Access Compliance Report

Public Rights-of-Way

Intersection ID: 21614	Main Street: RITTENHOUSE_CR	Cross Street: SARDIS_RD_NORTH	Location: SE
ADA ID: D3F9C513804B	Ramp Type: PerpDiag	Initial Pass/Fail: Fail	Overall Compliance: No
		Severity Score: 35

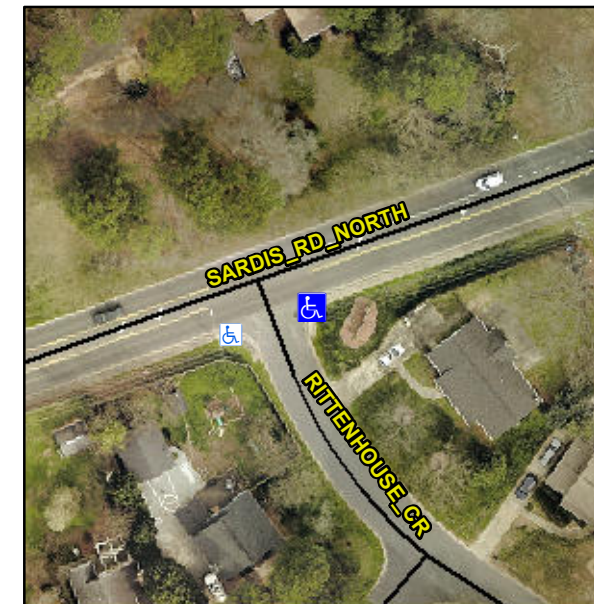
Not Found, R304.5.1, R304.2.2, R304.5.3

Compliance	Description	Data	Compliance	Description	Data
N/A	Ramp Length (in)	48.0	No	Ramp Slope (%)	12.6
No	Ramp Width (in)	44.0	No	Ramp XSlope (%)	4.3
N/A	Flare Type LT	N/A	N/A	Flare Type RT	N/A
N/A	Flare Slope LT (%)	N/A	N/A	Flare Slope RT (%)	N/A
N/A	Flare Traversable LT?	N/A	N/A	Flare Traversable RT?	N/A
N/A	Landing Length (in)	N/A	N/A	DWS Provided?	N/A
N/A	Landing Width (in)	N/A	N/A	DWS Contrast?	N/A
N/A	Landing Slope (%)	N/A	N/A	DWS Length (in)	N/A
N/A	Landing X Slope (%)	N/A	N/A	DWS Full Width?	N/A
N/A	Landing Curb? (Y/N)	N/A	N/A	DWS Offset (in)	N/A
N/A	Shared Landing?	N/A			
N/A	Gutter Ponding?	N/A	N/A	Gutter Slope (%)	N/A
N/A	Gutter Lip Ht (in)	N/A	N/A	Gutter X Slope (%)	N/A
N/A	Painted X Walk1?	No	N/A	Painted X Walk2?	No
	X Walk 1 Direction	To N		X Walk 2 Direction	To W
N/A	X Walk 1 Width (in)	N/A	N/A	X Walk 2 Width (in)	N/A
	X Walk 1 Slope (%)	4.0		X Walk 2 Slope (%)	4.2
	X Walk 1 X Slope (%)	3.3		X Walk 2 X Slope (%)	3.3

Remove & Replace Curb Ramp With Two New Directional Ramps or Equivalent.
